S19AG

Subject: S19AG, Air Conditioning Relay

Models Affected: Model Year: Certain 2015 to 2021 (School Bus and Non-School Bus)
Model: Vision and All American

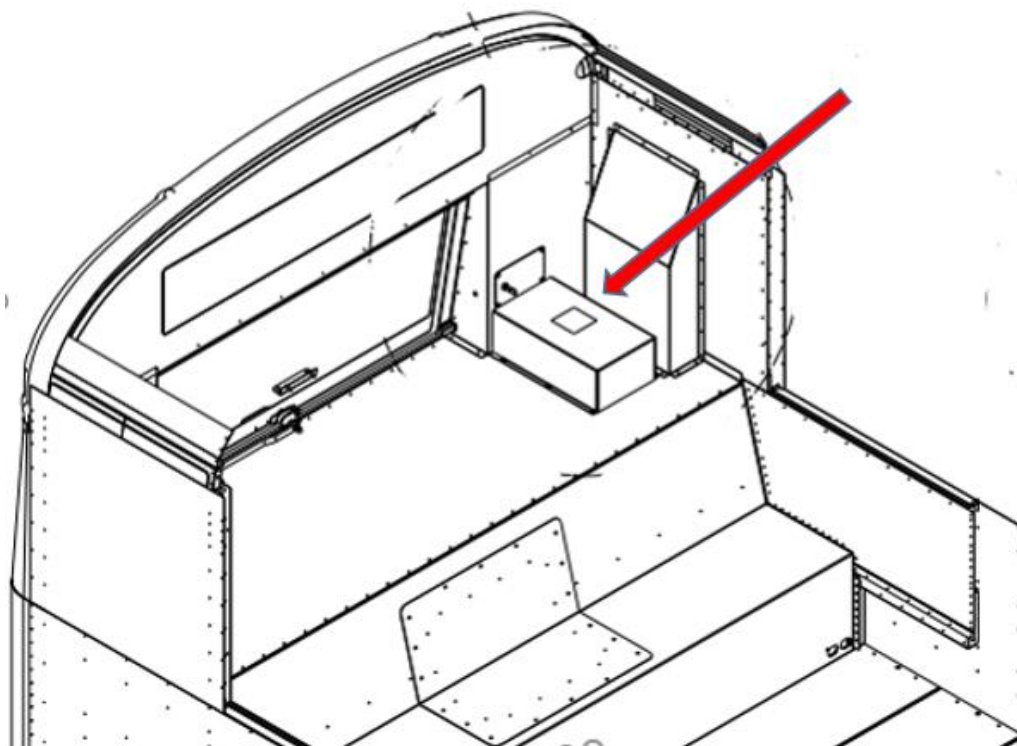
1. Locate the air conditioner relays and harness assembly.
 - a. For Vision and Front Engine All American the relays are in air conditioner electrical compartment which is on the left-hand skirt panel rear of the battery compartment.

2. Open the compartments and locate the four relays indicated that are used in the air conditioning circuit.

3. Remove the CIT brand relays and replace with the Song Chuan brand.
4. Inspect harness 10023917 connected to the relay base for any sign of damage and replace, if necessary.

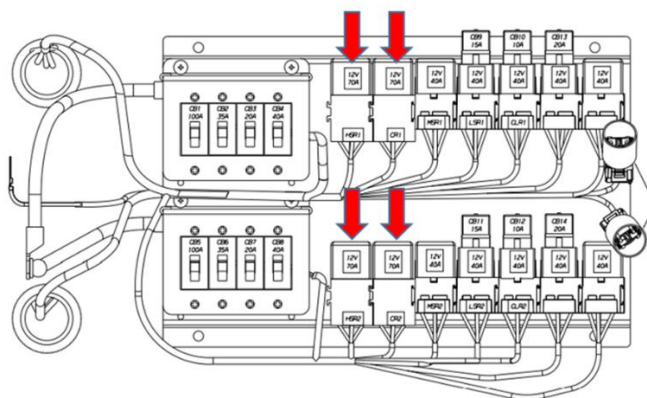
- b. For Rear Engine All American the relays are in the air conditioner electrical compartment, which is located on the rear davenport deck.
